CONTRACT CHANGE ORDER

CCO: 229 Suppl. No. 0 Contract No. 04 - 0120F4 Road SF-80-13.2/13.9 FED. AID LOC.:

Refabricate the PS-3 pipe supports for the 4" NPS Compressed Air line along the bikepath, and modify the PS-6 and PS-7 pipe supports to maintain a consistent 22 mm clearance between the PS-3 hinge and the edge of the bike path. This will ensure a minimum of 19 mm of clearance between the suspender brackets and the 4" NPS Compressed Air line.

CONTRACT CHANGE ORDER NO. 229
 SHEET 3 OF 3

PIPE SUPPORT DETAIL PS-7 (Attachment to Concrete)

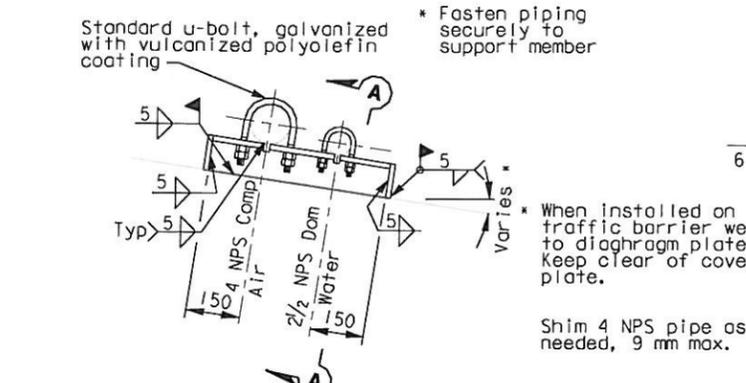
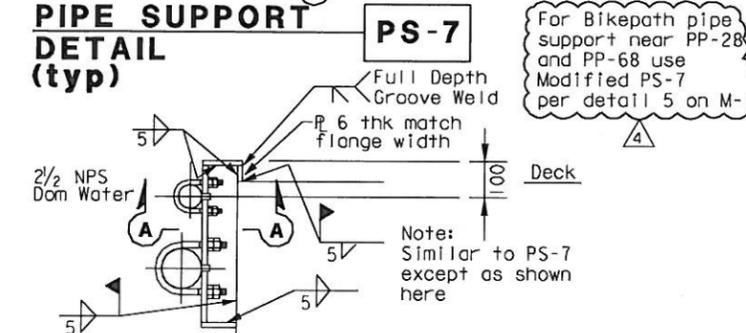
As directed by the Engineer, field verify that the modifications to the PS-6 pipe support maintained 19 mm of clearance between the suspender brackets and the 4" NPS Compressed Air line. If 19 mm clearance is not achieved through modifications above then perform further modifications to ensure acceptable clearance.
